PRELIMINARY/FINAL DRAINAGE REPORT

JACKSON OFFICE WAREHOUSE STORAGE BUILDINGS DEVELOPMENT

ROCKY MOUNTAIN INDUSTRIAL PARK

PCD File No. PPR-17-057

JACKSON OFFICE WAREHOUSE & STORAGE BLDGS
8140 SANDY COURT
EL PASO COUNTY, COLORADO
PRELIMINARY DRAINAGE PLAN

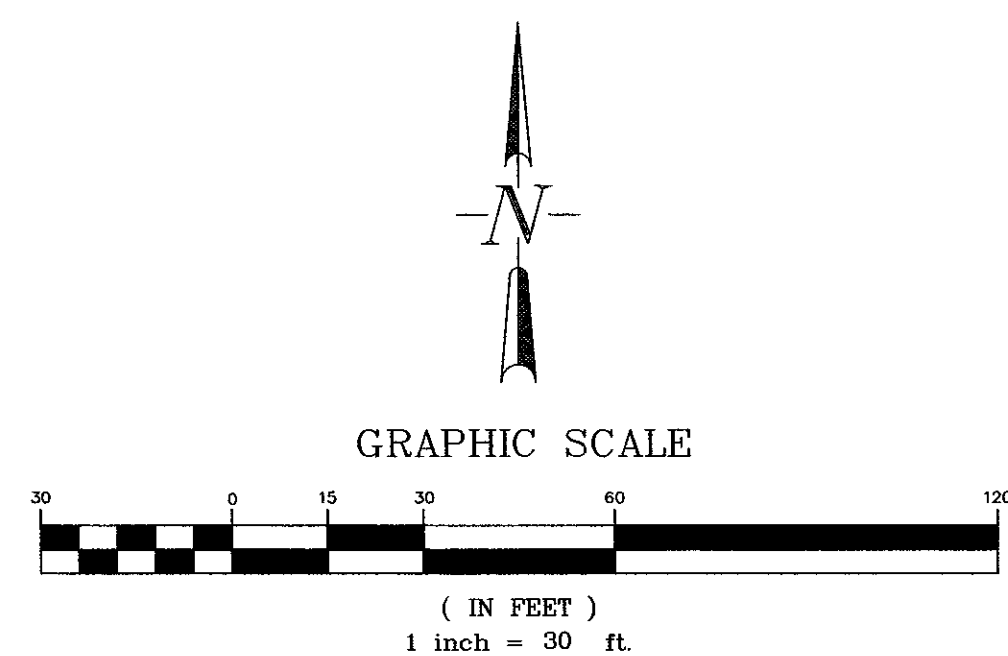
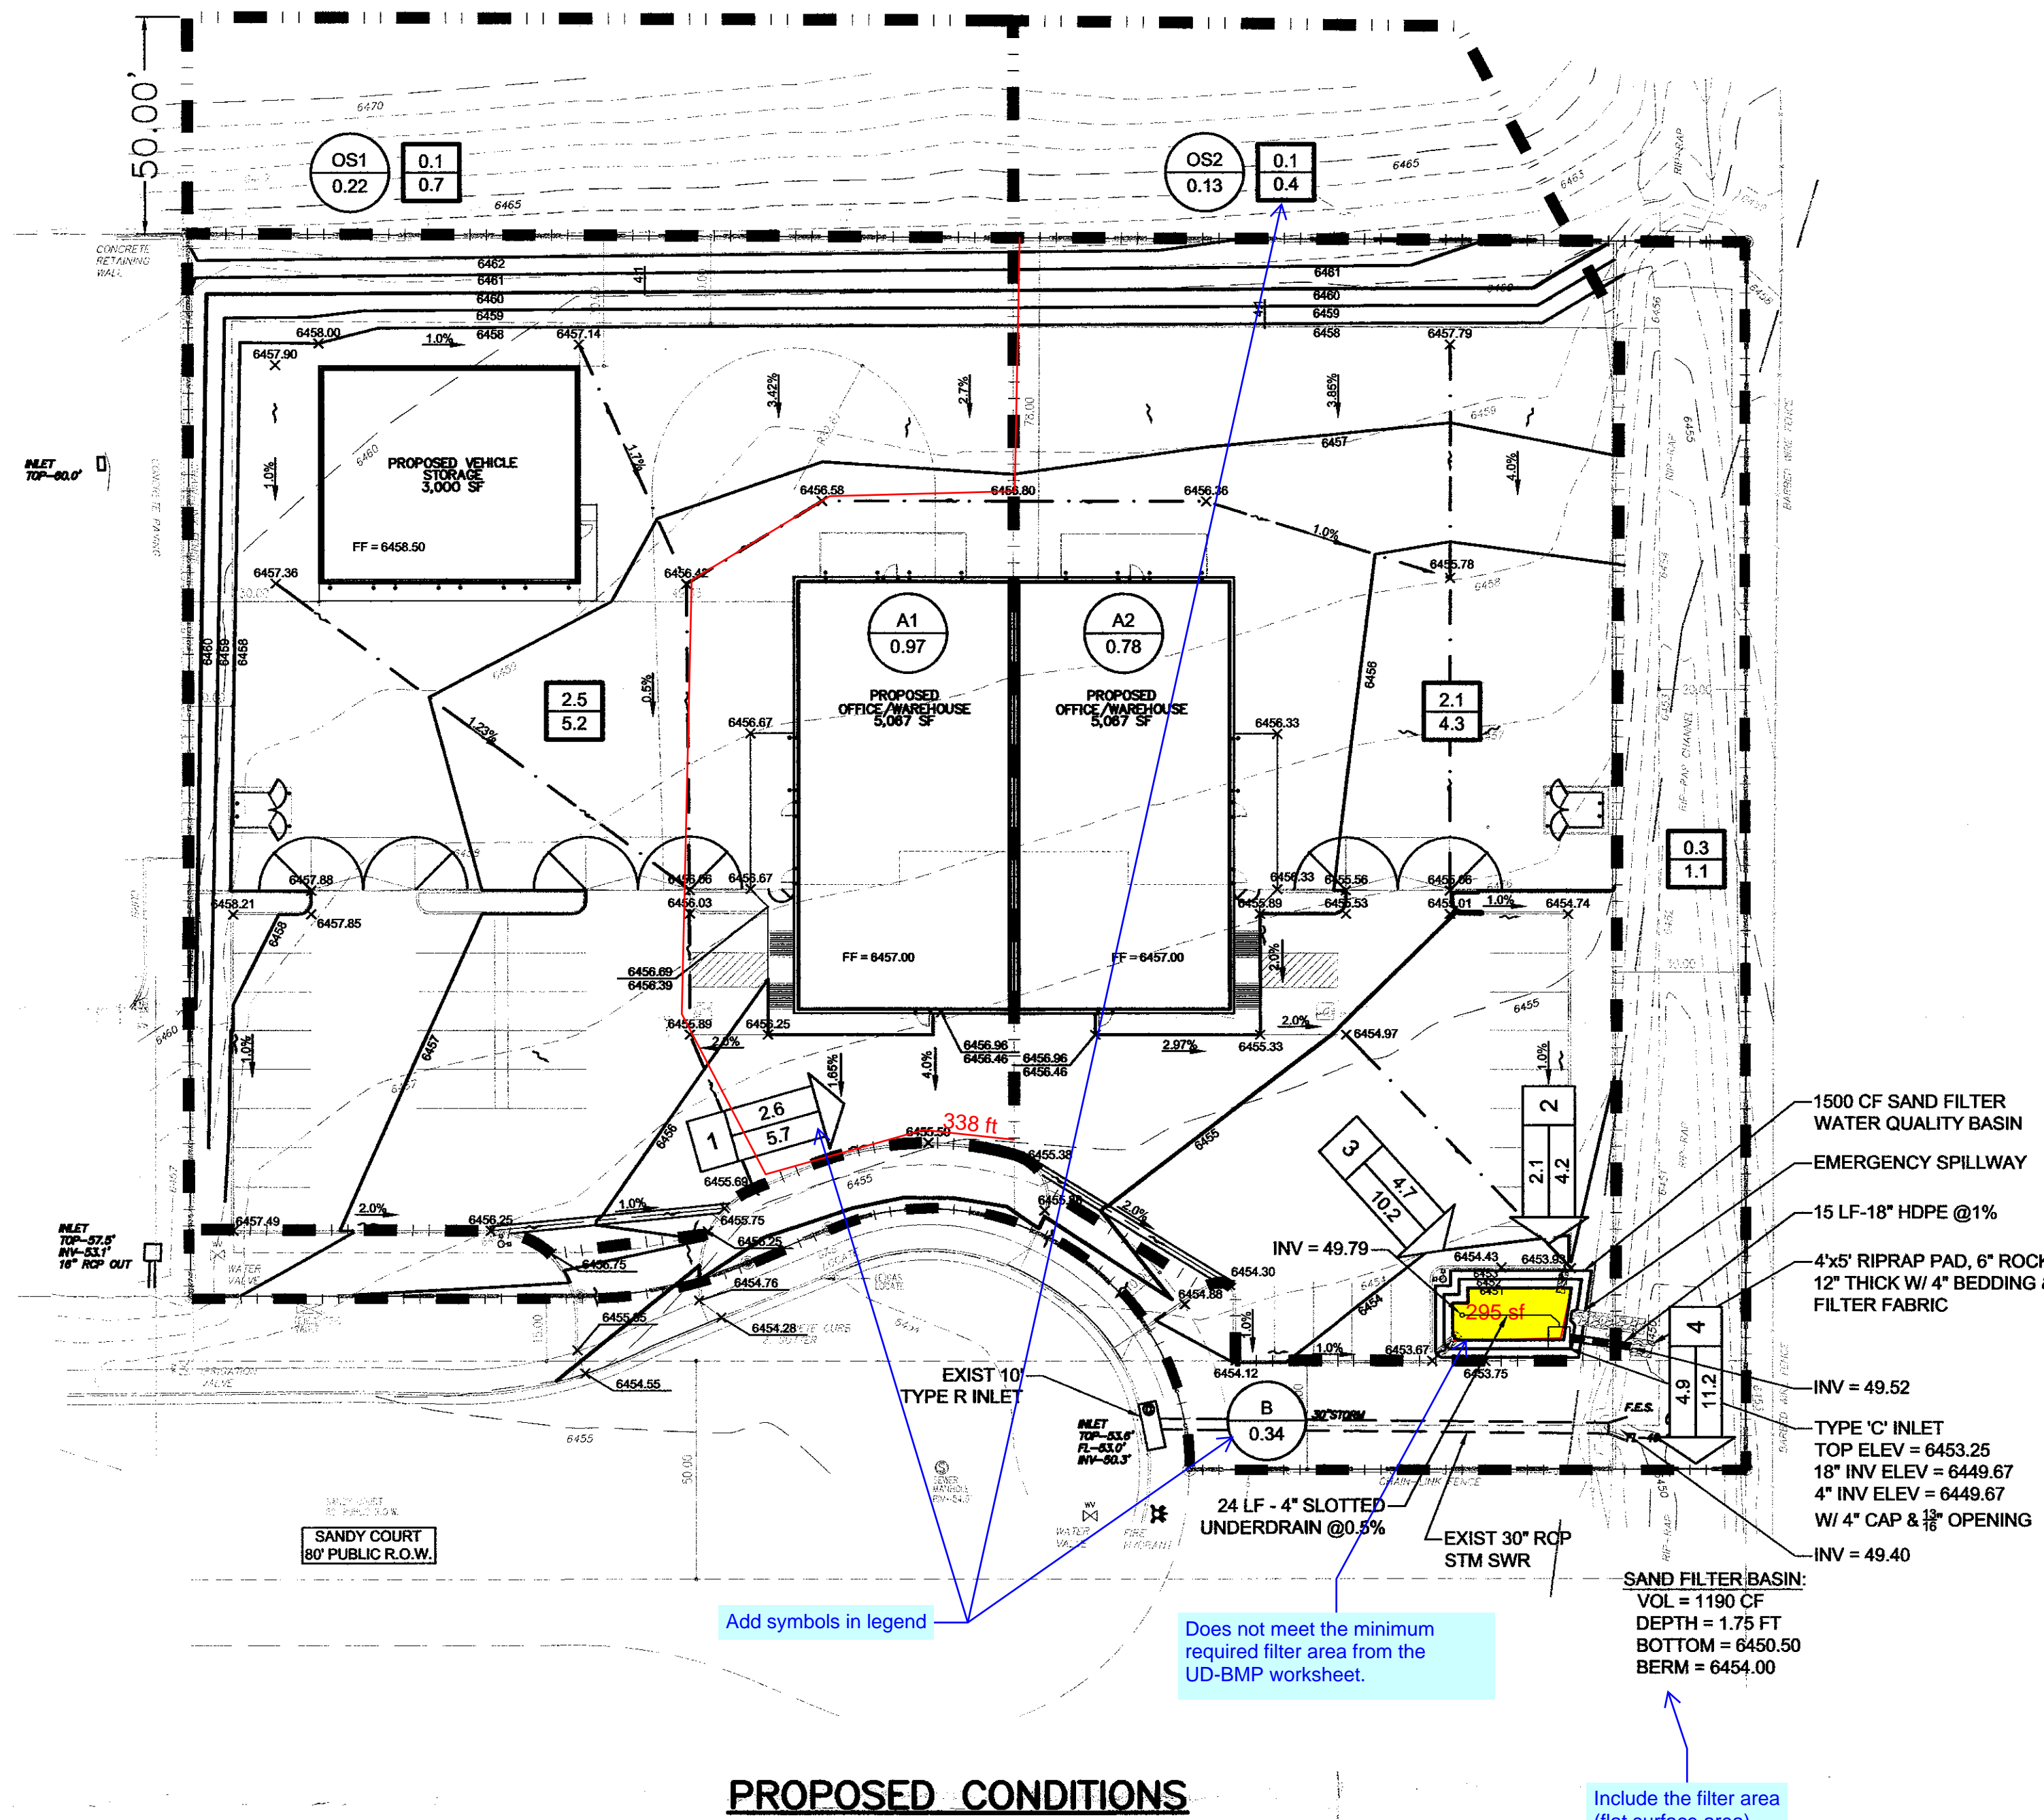
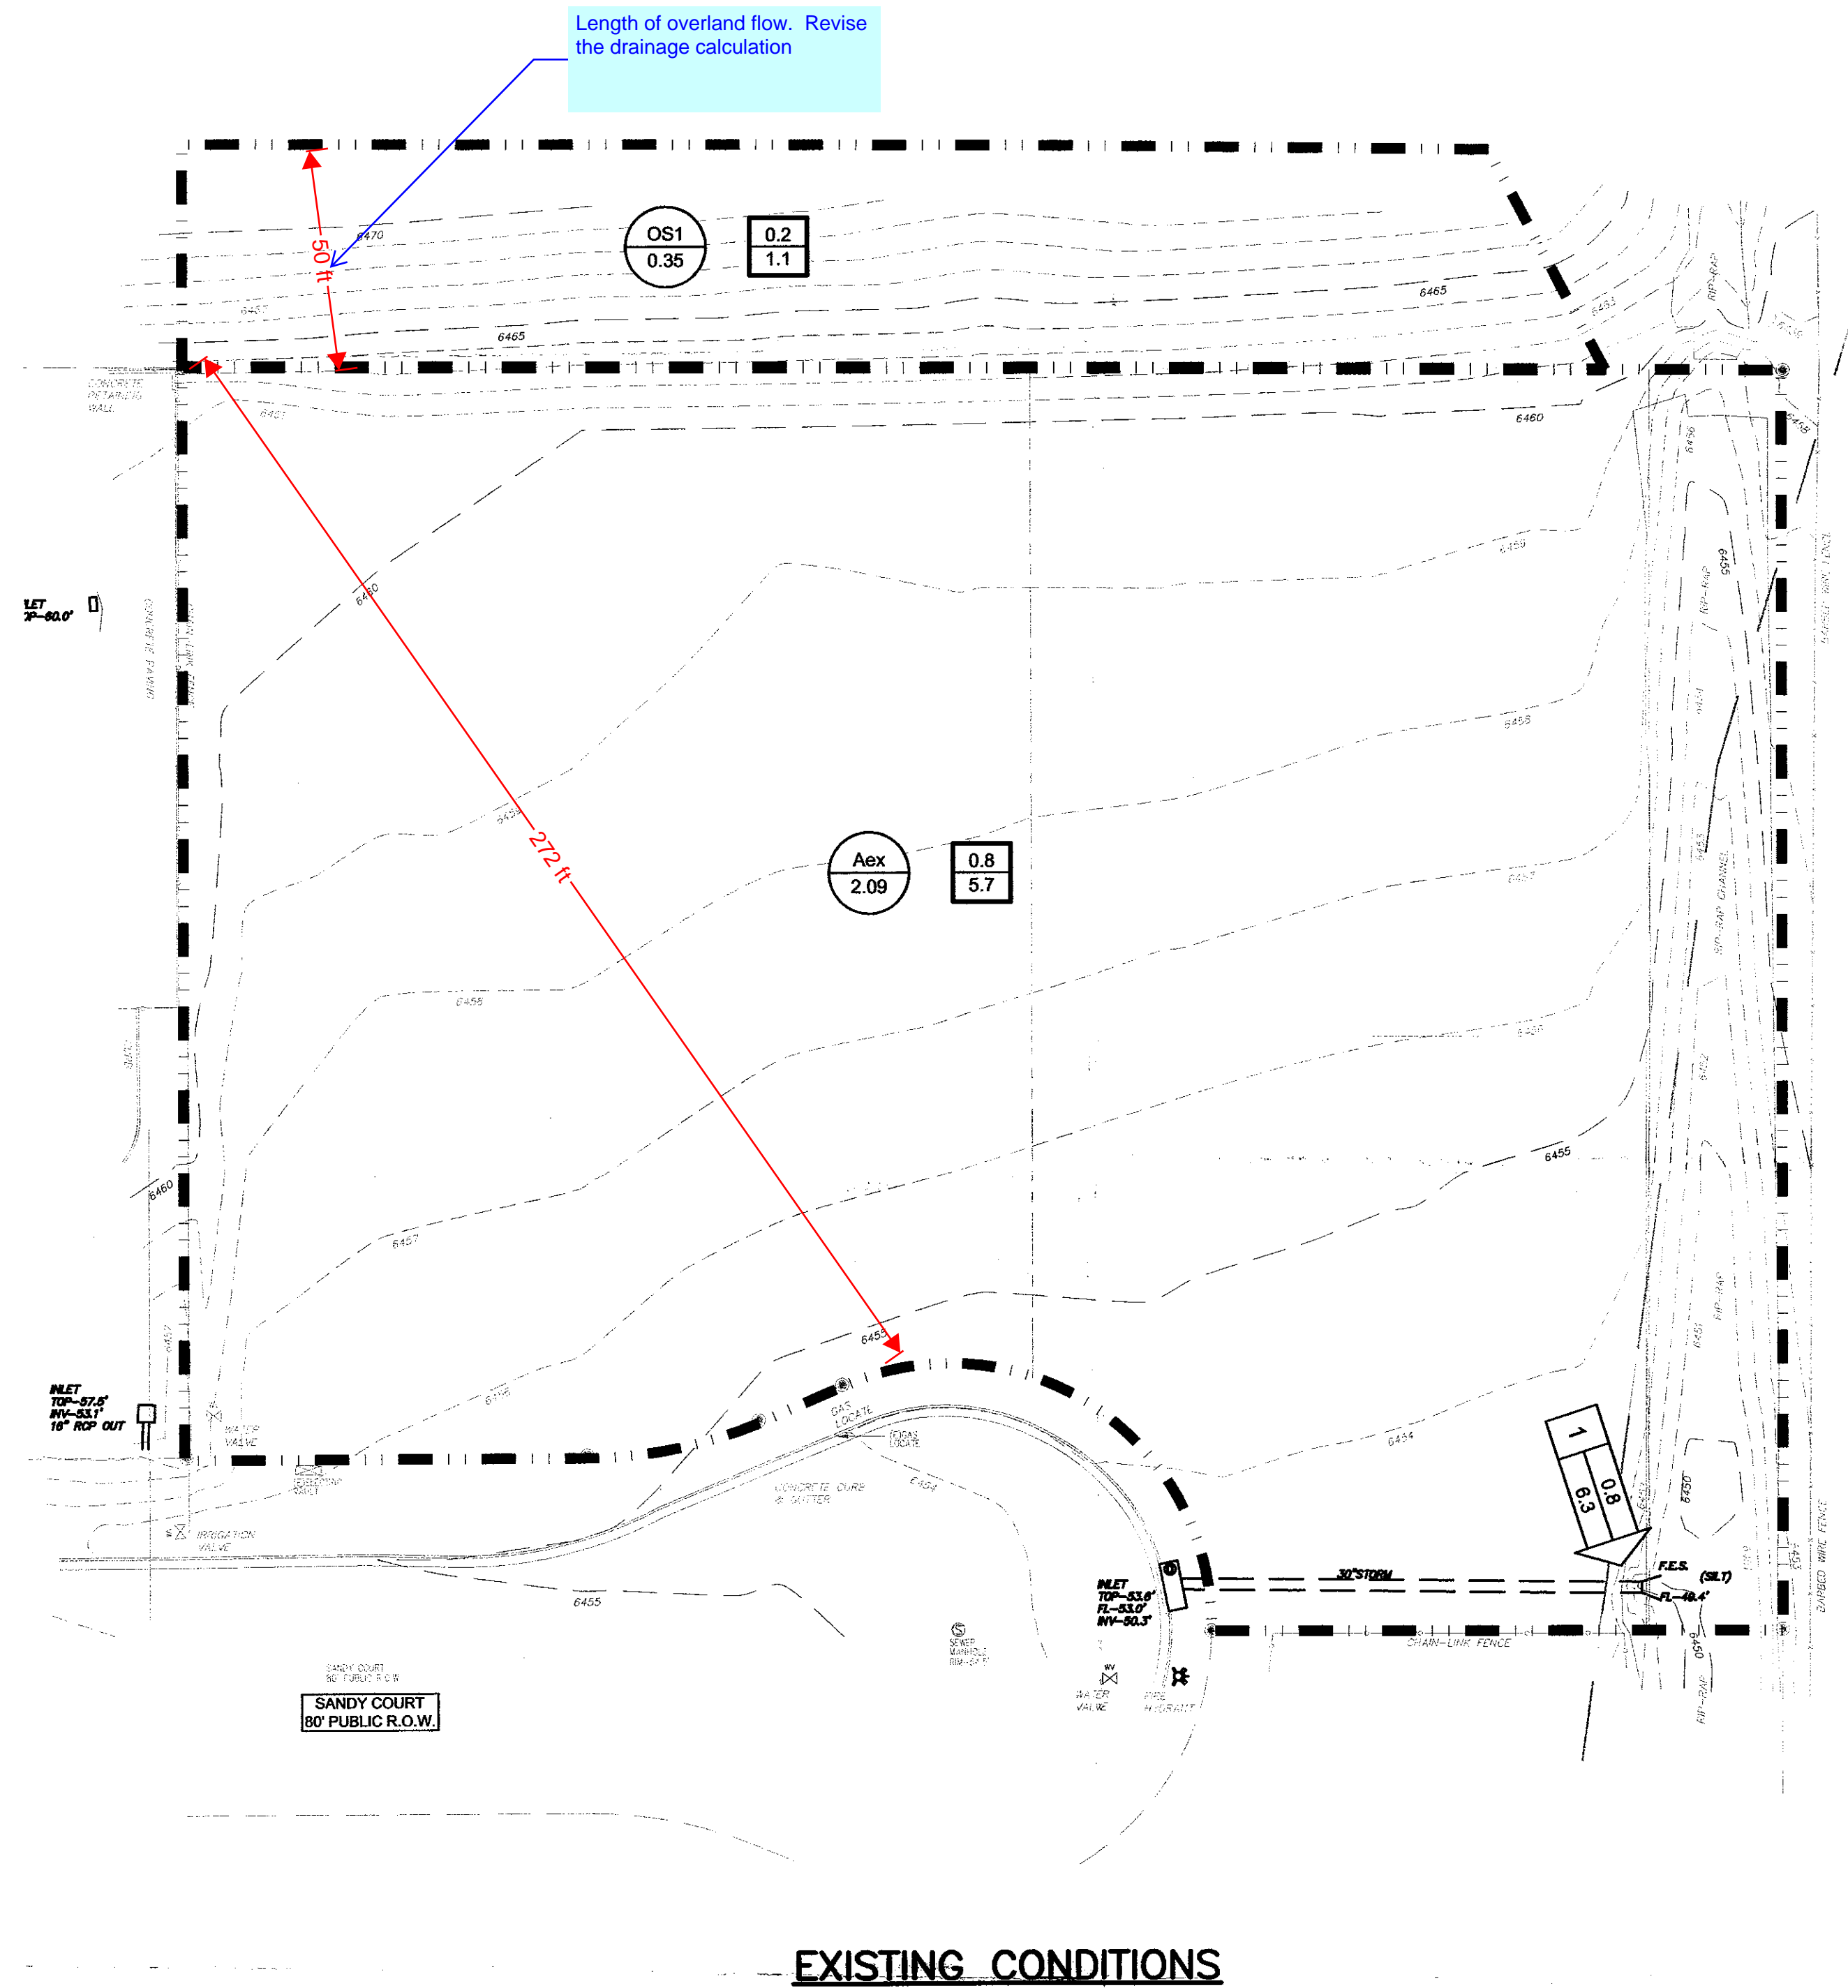
Include the filter area (flat surface area)

Add symbols in legend

Does not meet the minimum required filter area from the UD-BMP worksheet.

295 sf

Length of overland flow. Revise the drainage calculation
